Technical Bulletin

Tall Bottom Rail Profile

FM-7.5-216
Rev B
02-15-08

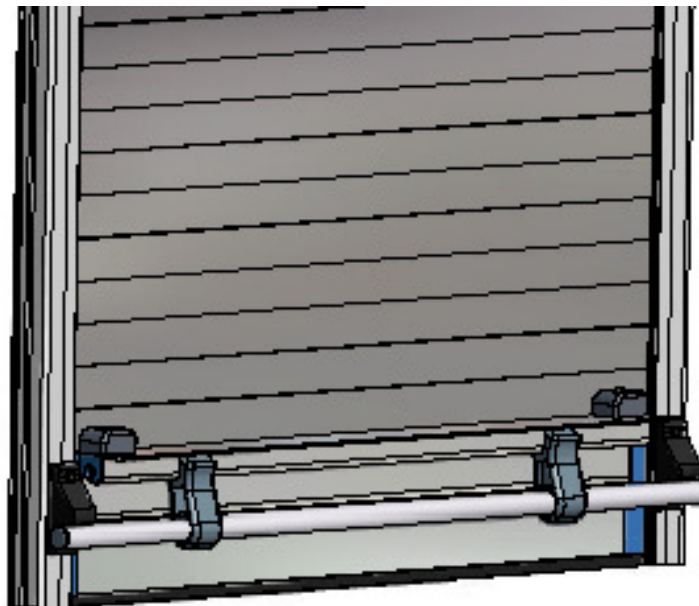
R•O•M is proud to announce our Tall Bottom Rail option for R•O•M Series III Roll-up Shutters. Additional hand clearance is often needed when a compartment's threshold extends out beyond the vertical plane of the curtain's outer surface. This new single piece Bottom Rail profile adds 1 1/2" of additional clearance between the Liftbar and threshold. The same clean R•O•M Series III Bottom Rail look is preserved while providing adequate hand clearance when wearing gloves.

The Tall Bottom Rail option will replace our two piece Bottom Rail with Extension add-on which provided additional 1/2" clearance.

The Tall Bottom Rail reduces the compartment opening height by 1 1/2". Typically this is a non-issue since the bottom of the curtain roll is approximately in the same location.
